# ENGINE STARTING SYSTEMS, PLESSEY, TYPE I.P.N.

## GENERAL ORDERS AND MODIFICATIONS

Starting System - Intro  
Control Unit Assembly  
Part No 700/1/12170

AP 103D-0208-2  
Leaflet No 4

FIG1

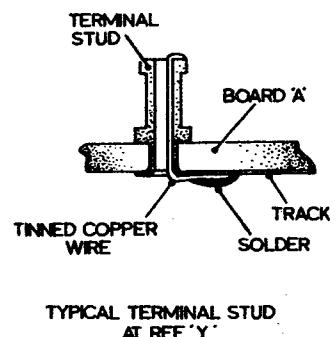
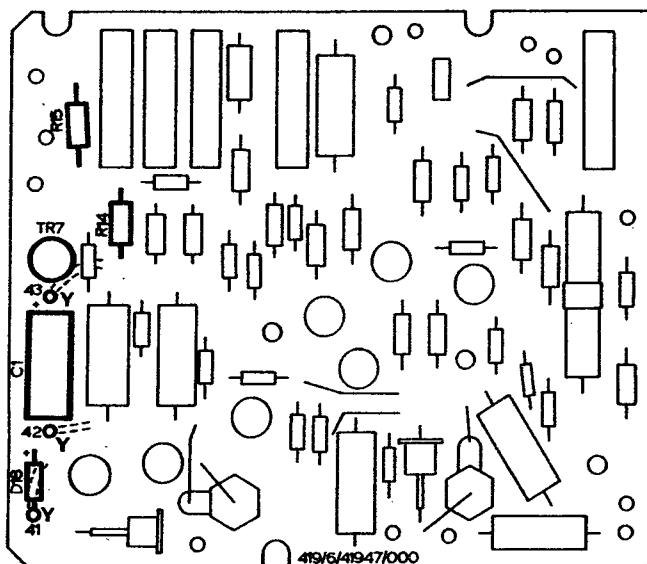
(4) Refer to Drawing Plessey / 2635 Fig 1. From Board A Part No 419/1/09599 unsolder and remove the following:

R15 Resistor

TR7 Transistor

C1 Capacitor

D18 Diode

Remove the identifying coding, R15, TR7, C1 and + sign, D18 and + sign.

(5) Drill out three existing holes, Ref Y, to 1.95 mm diameter and fit Terminal Studs (Qty 3), Part No 999/4/01135/004. Studs to be swaged and wired to track using Tinned Copper Wire 0.5 mm diameter and Solder, Multicore 22 SWG (See sketch).

(6) Remove Board Part No 419/1/09599. Using white ink re part number to 419/6/41947/000. Code reference identity of new Terminal Studs 41, 42, 43, alongside each as shown. Using varnish, reprotect exposed areas.

FIG2

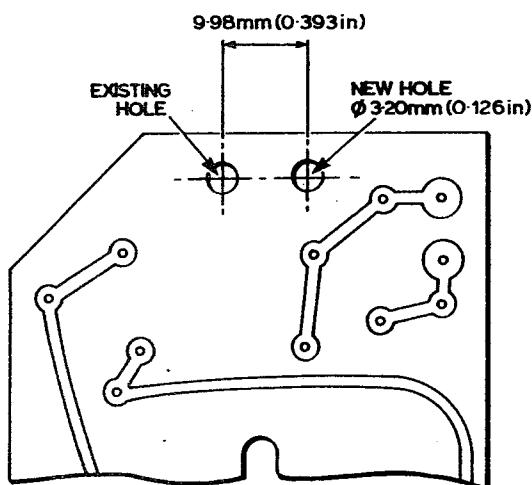
(7) Refer to Drawing Plessey / 2635 Fig 2. Rework Board 'B' Part No 700/1/12711 by drilling hole 3,20 mm diameter at position shown. Recode Board as 419/1/41975/000.
